REMARKS/ ARGUMENTS

Figure 7

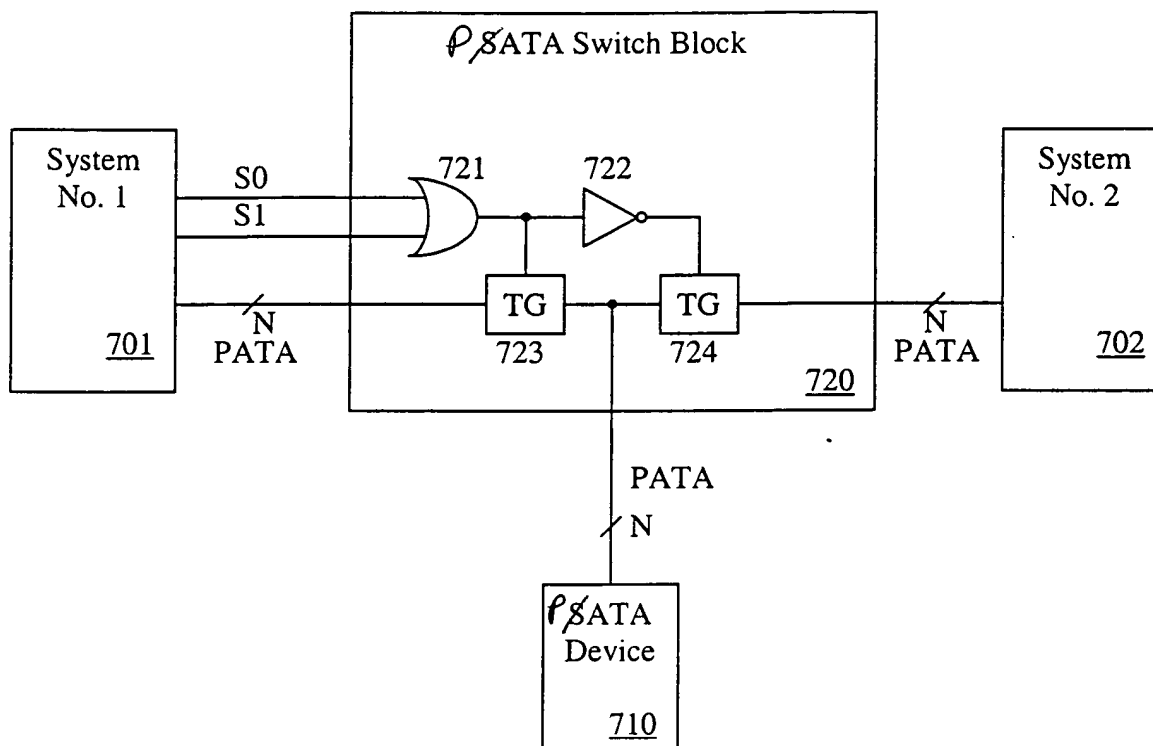
The Examiner objected to the drawings as failing to comply with 37 CFR 1.84(p)(5) because they include the following reference sign(s) not mentioned in the description: SATA Switch Block 720 and SATA Device 710.

Corrected drawings are submitted with the current response.
